MERCROUISER SERVICE BULLETIN

Number: 70-12-08

Overheating of Instrument Panel Harness and Engine Harness (Sec. II)

Figure 2. Red/White Wire Shorted to Ground Stud

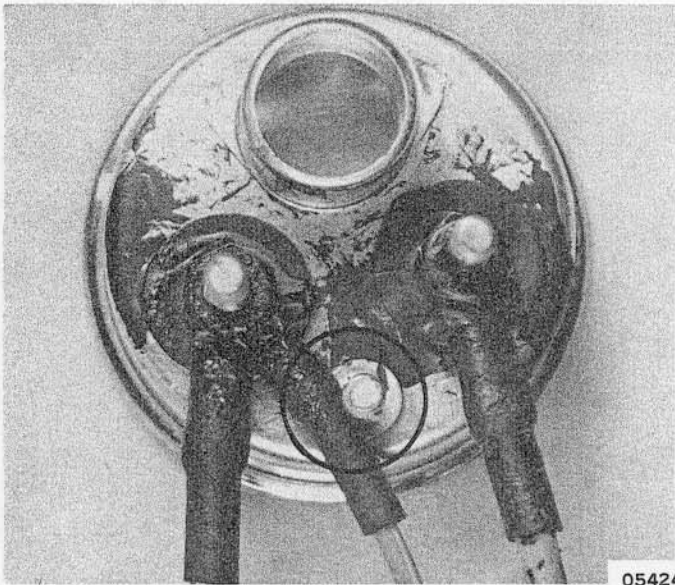
1. Disconnect ALL cables from battery.
2. Visually inspect red and red/white wire connections at back of ammeter for shorted conditions as shown in Figures 2-3-4.

3. If connections are as shown in Figure 2 or 3, loosen terminal nut and pivot terminal away from ground stud to provide clearance as shown in Figure 5.
